## **ADDENDUM NO. 2**

**DATE:** August 26, 2020  
**FROM:** City of Grand Junction Purchasing Division  
**TO:** All Offerors  
**RE:** 2020 Sewer Line Replacement Project  
IFB-4821-20-DH

# CITY OF GRAND JUNCTION 2020 SEWER LINE REPLACEMENT PROJECT AUGUST 2020

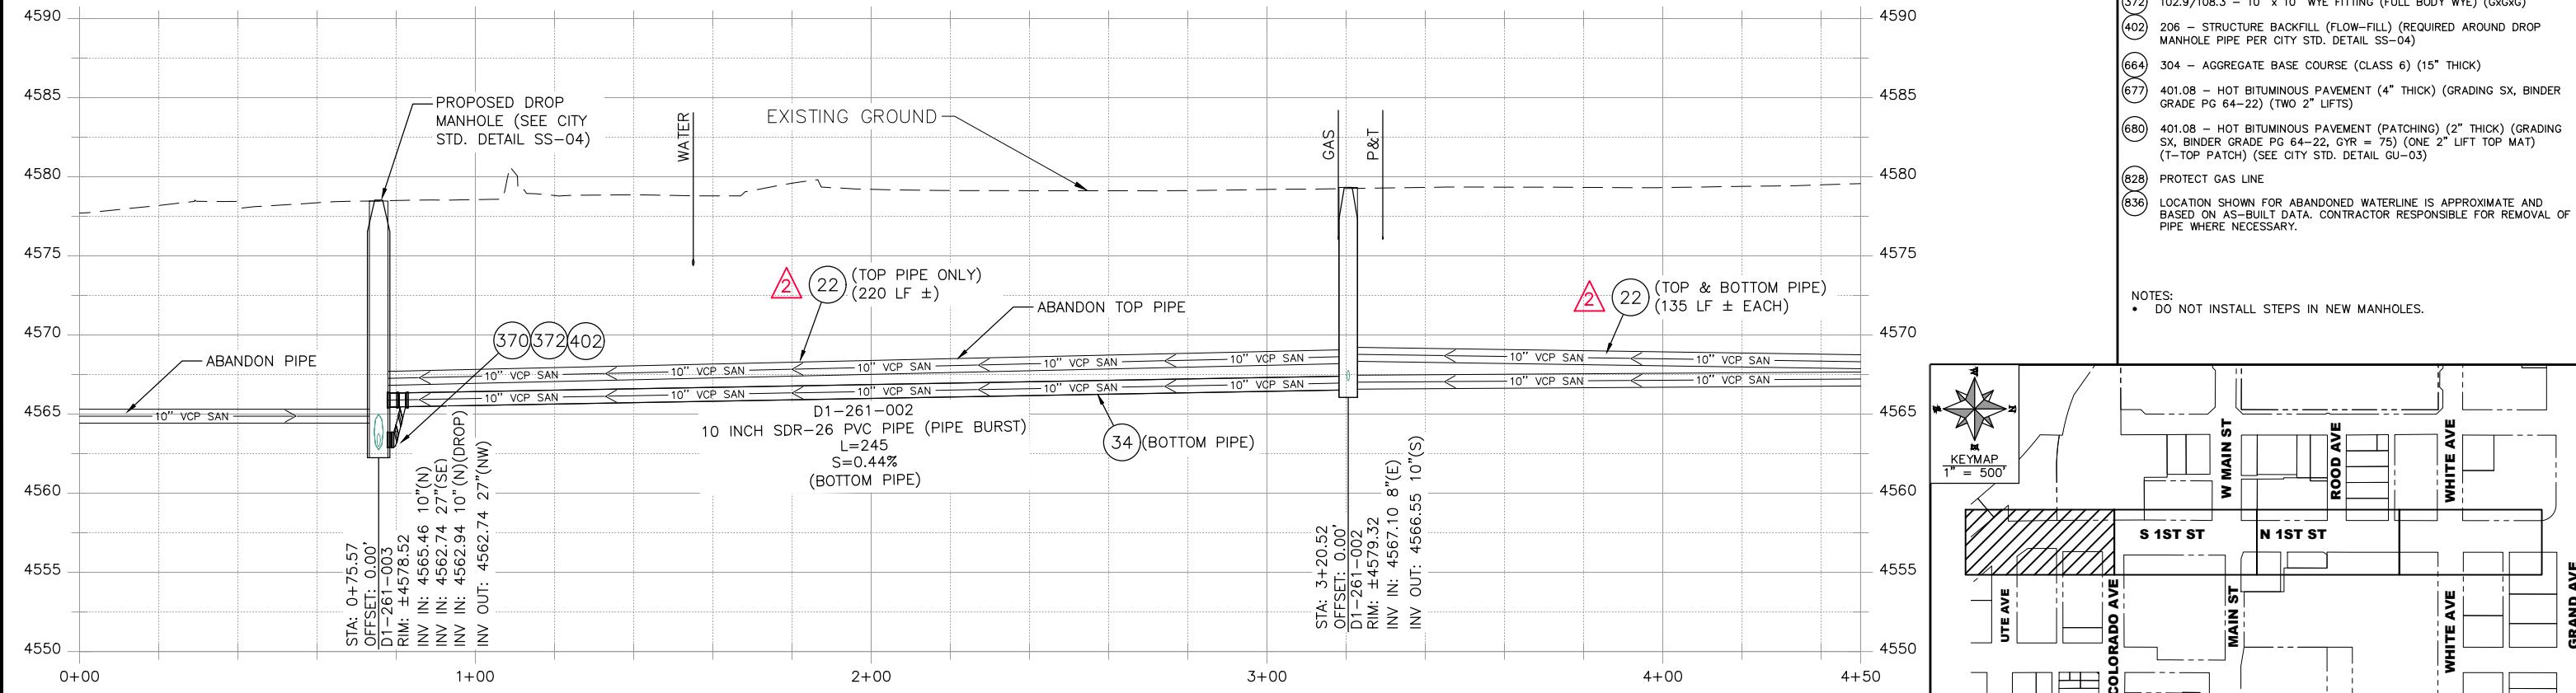
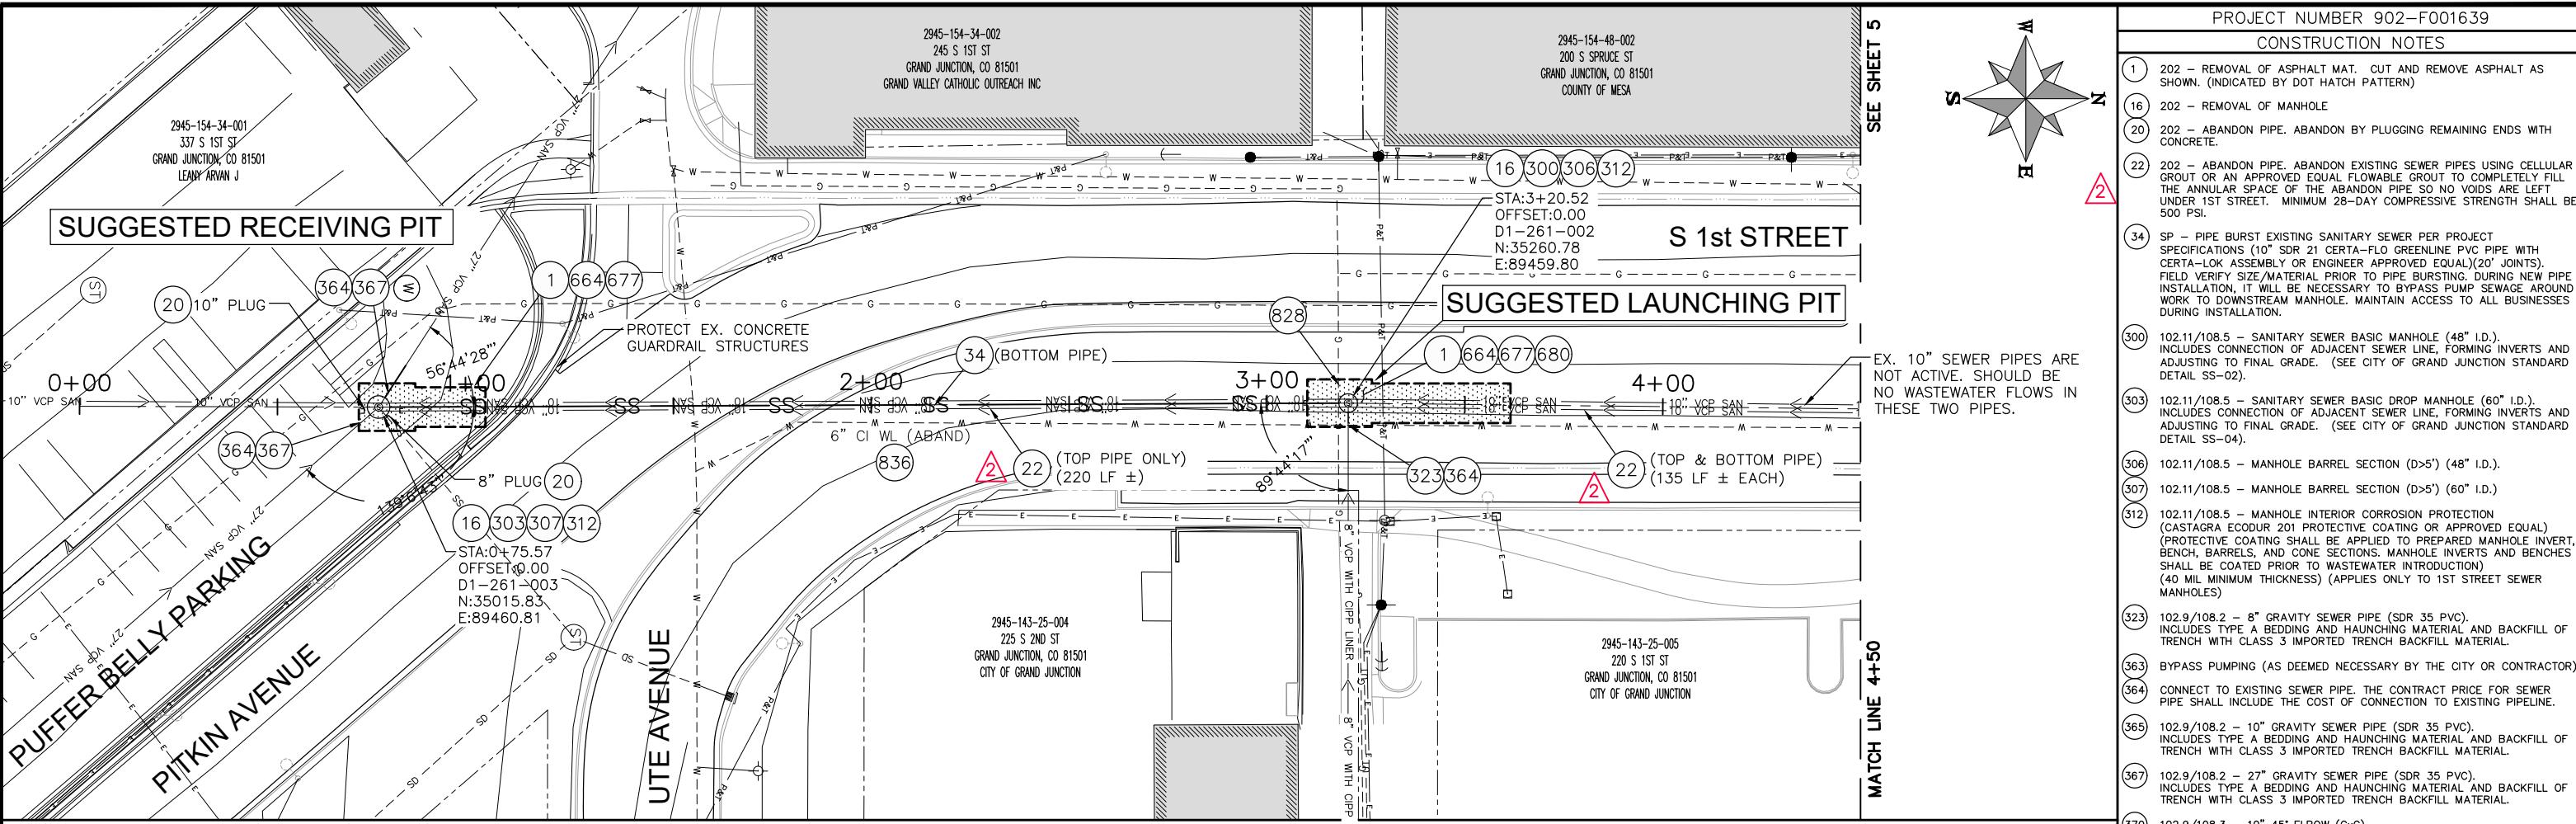
22.Q. Page 4 – Connect to existing 27" VCP (x2), what kind of coupling is wanted since the MAX adapter coupling is not made in that size...regular Fernco, RC Fernco? Also, is there any way to verify the O.D. of existing VCP, to ensure proper size range of coupling is ordered?

A. *Due to the outside diameter differences between vitrified clay pipe and PVC sewer pipe, the City recommends using regular Fernco rubber couplings. The Contractor will be required to pour a concrete collar around the Fernco coupling to provide pipe support prior to backfilling pipes. There's no way for the City to determine the exact O.D. of the existing 27" VCP sewer pipe. From the EBAA Iron Pipe O.D. Chart, which is available on the internet, the O.D. of 27" clay pipe can be either 31" or 32.13".*

2020 SEWER LINE REPLACEMENTS  
SHADOW LAKE SEWER PLAN & PROFILE  
STA 0+00 TO 3+20

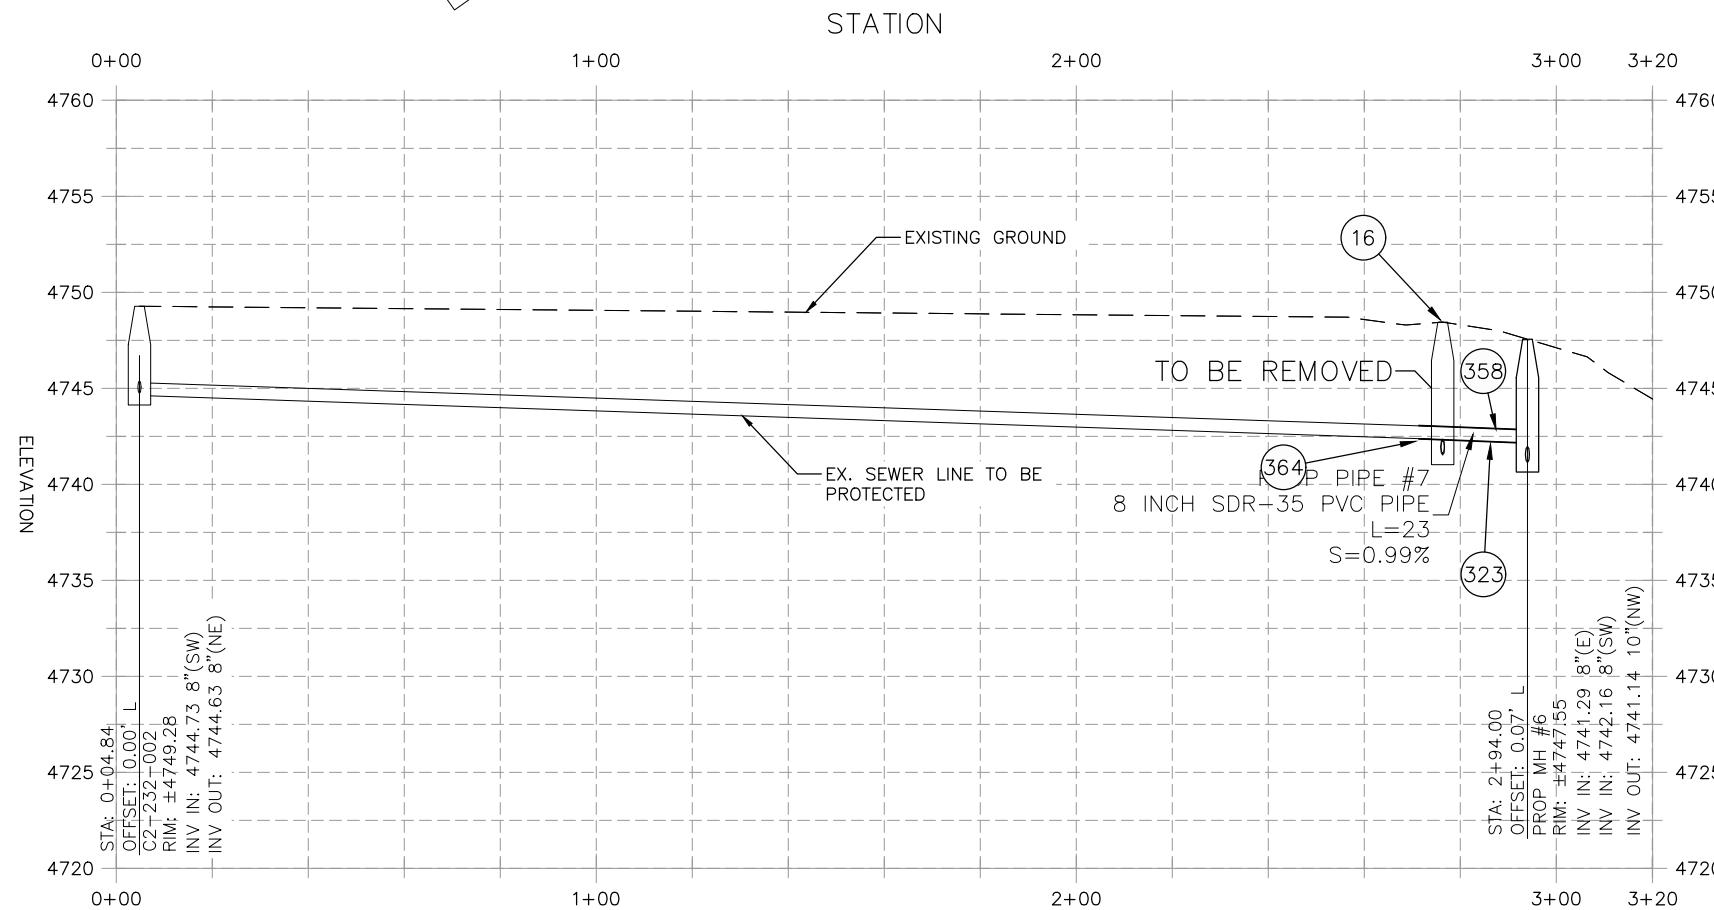
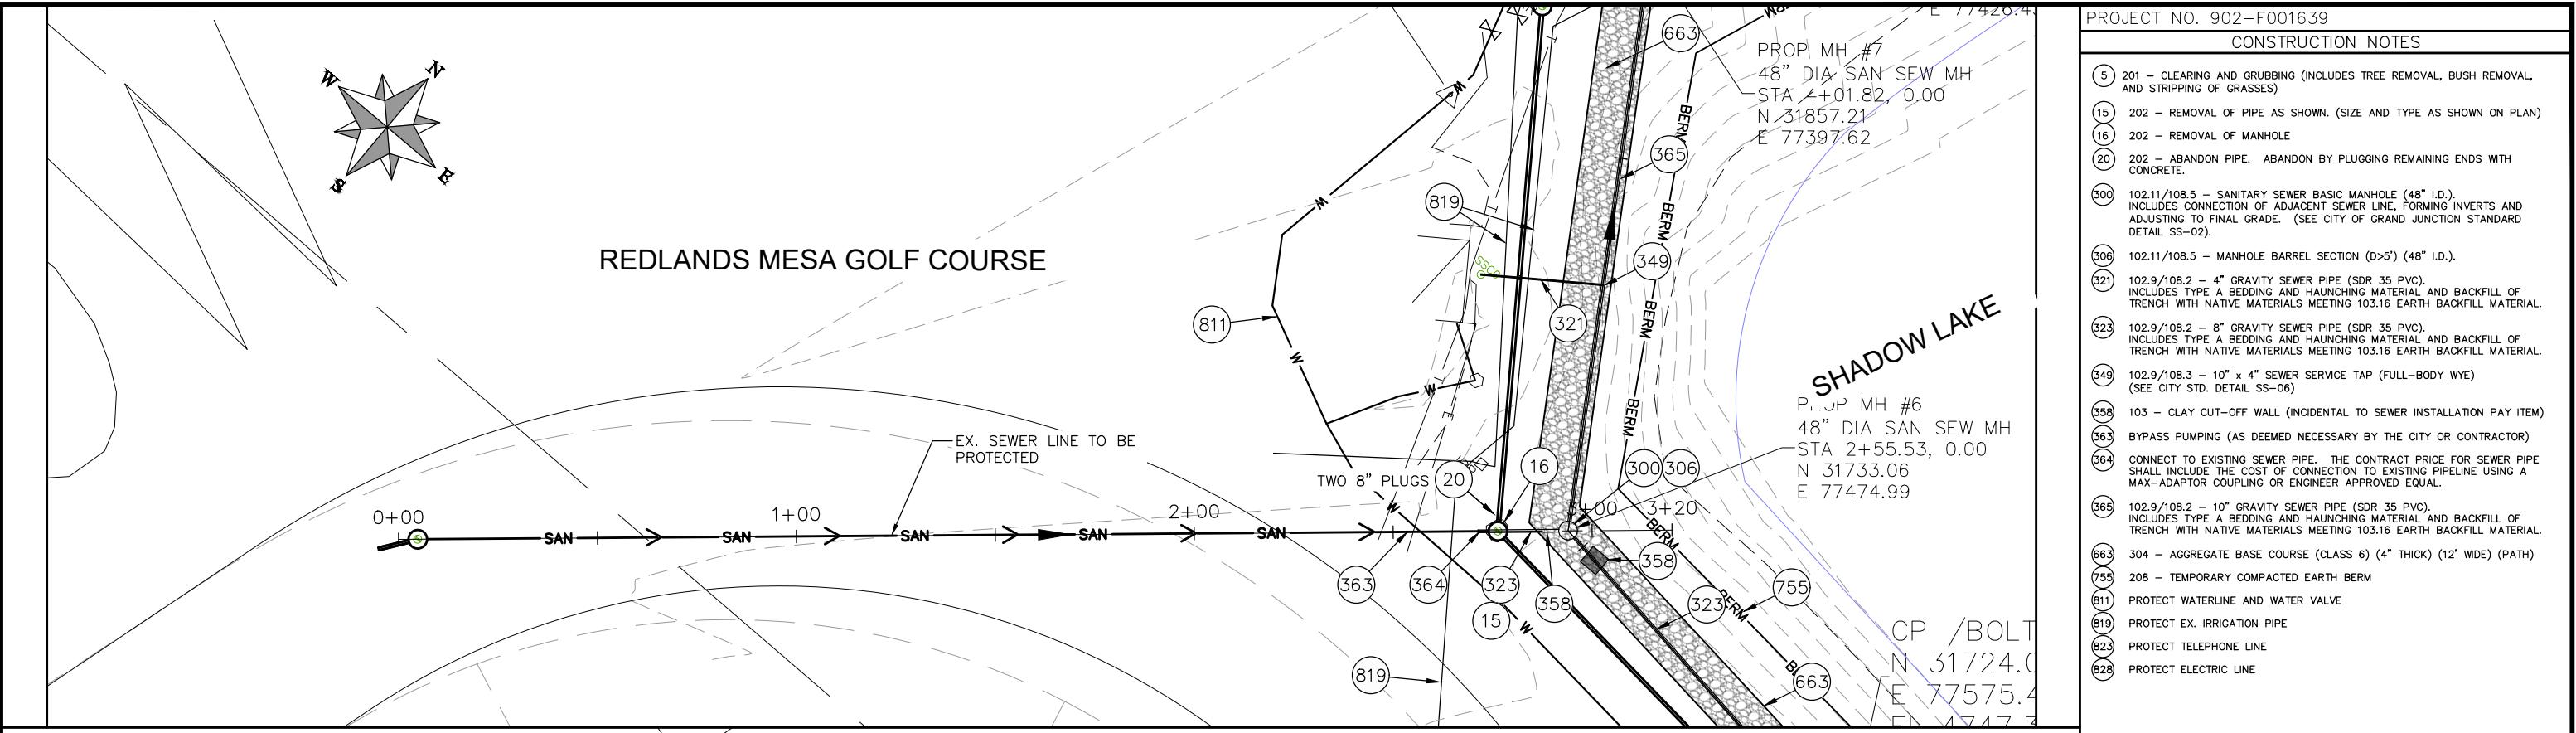
20.Q. Sheet 10, at Sta: 2+42.86, the plan view calls for 323, 364 in the North East direction. However, we could not find an existing pipe flowing through the NE direction. Can you please clarify as to what is to be required at that location?

A. *There is an existing 8-inch sewer pipe coming from the NE that will need to be extended to the new sewer manhole at Station 2+99.80. The City verified this pipe on 8/25/2020.*
